SUBJECT: **SP24-012: Parker Central Area F5 L2 B1 - McDonalds– Site Plan Amendment Review Comments 03**

SITE DEVELOPMENT PLAN
MCDONALDS REMODEL AT PARKER CENTRAL AREA FILING NO. 5, BLOCK 1, LOT 2

SHEET NO: C1.0

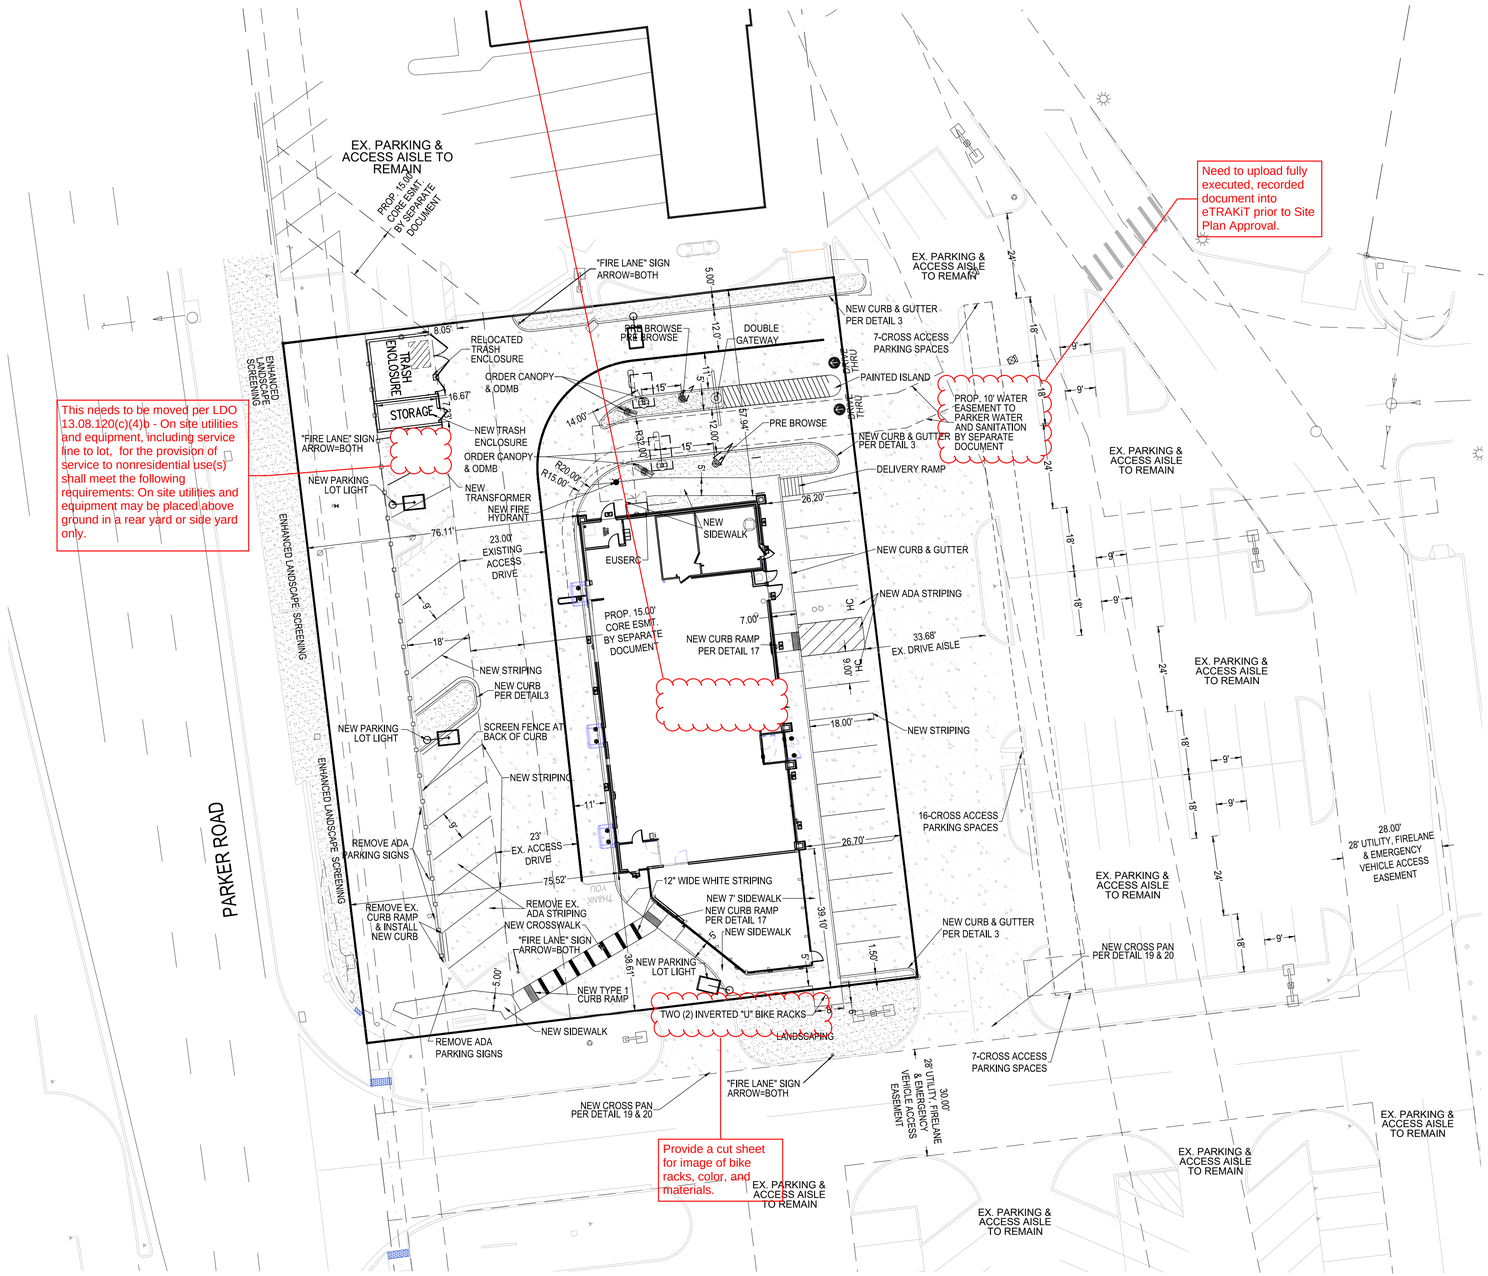
Need to upload fully executed, recorded document into eTRAKiT prior to Site Plan Approval.

This needs to be moved per LDO 13.08.120(c)(4)b - On site utilities and equipment, including service line to lot, for the provision of service to nonresidential use(s) shall meet the following requirements: On site utilities and equipment may be placed above ground in a rear yard or side yard only.

Provide a cut sheet for image of bike racks, color, and materials.

1 SOUTH ELEVATION
SCALE : 3/16" = 1'-0"

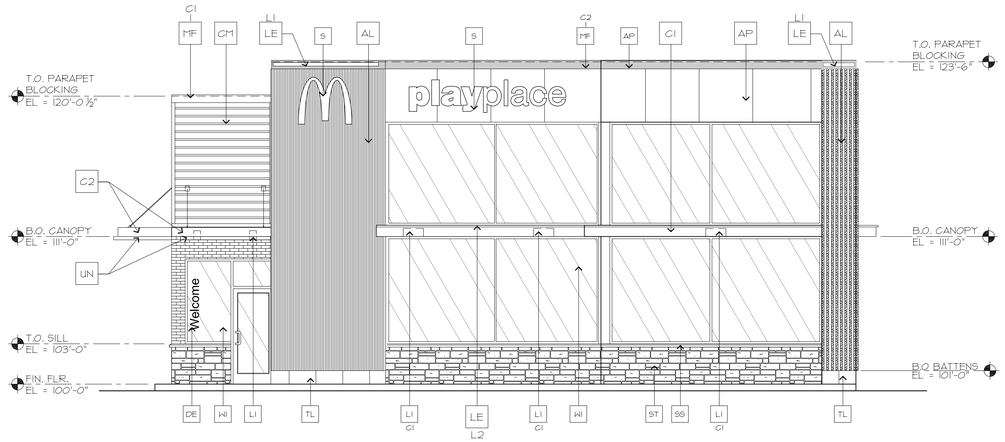
Everything Community Development is reviewing needs to be on these plans. Show guard rail on elevations and this site plan.

1 NORTH ELEVATION
SCALE : 1/4" = 1'-0"

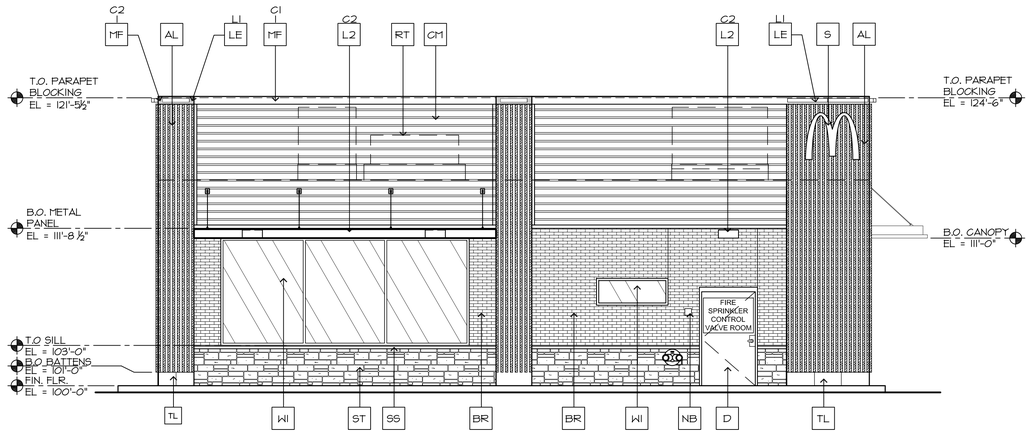
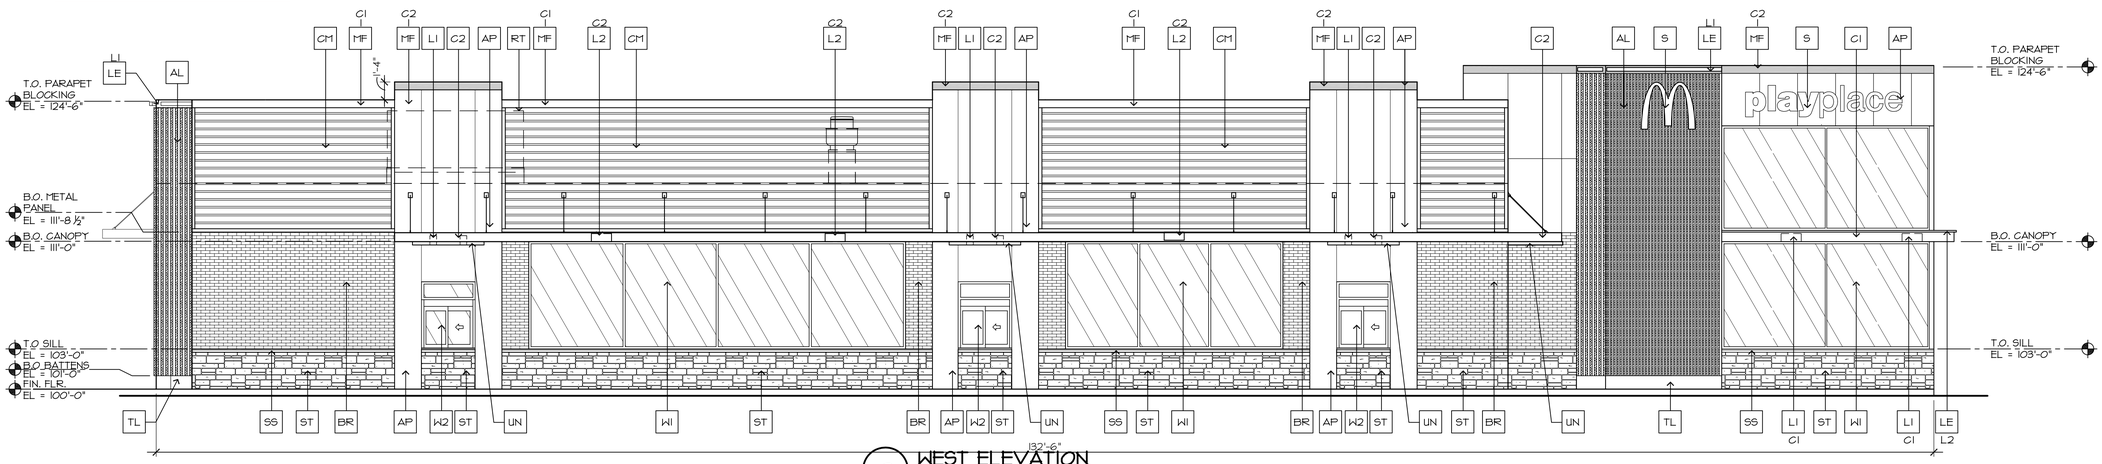
Per DDS X.A.2.c.i. 1-2, show transparency calculations for all facades.

Show wall-mounted electrical equipment, add note that it will be painted to match adjacent wall.

1 SOUTH ELEVATION
SCALE : 3/16" = 1'-0"

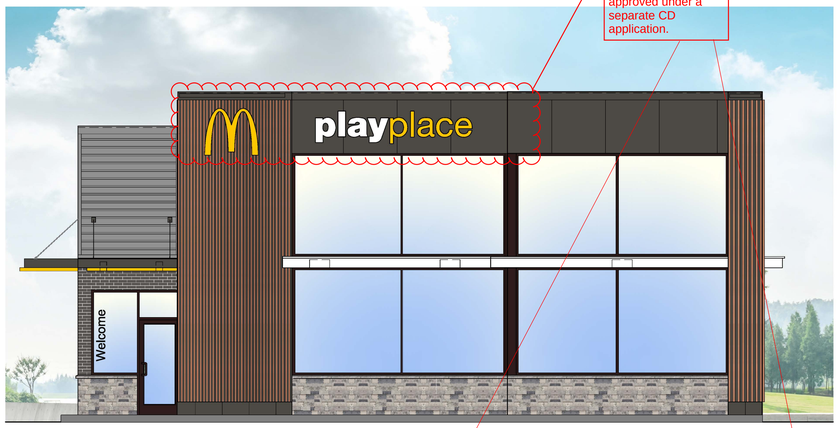
Remove or note that not part of this Site Plan and will be approved under a separate CD application.

Provide a material board to the Planning Division Office.

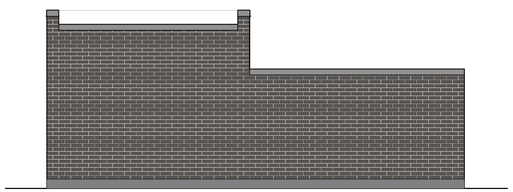
Need vertical massing break(s). Per DDS X.A.3.b.iii.3). Buildings over 100 feet in length shall require a vertical massing break at a distance of 25 to 50 feet.

See McDonalds SP21-067 Chambers Rd and Hess.
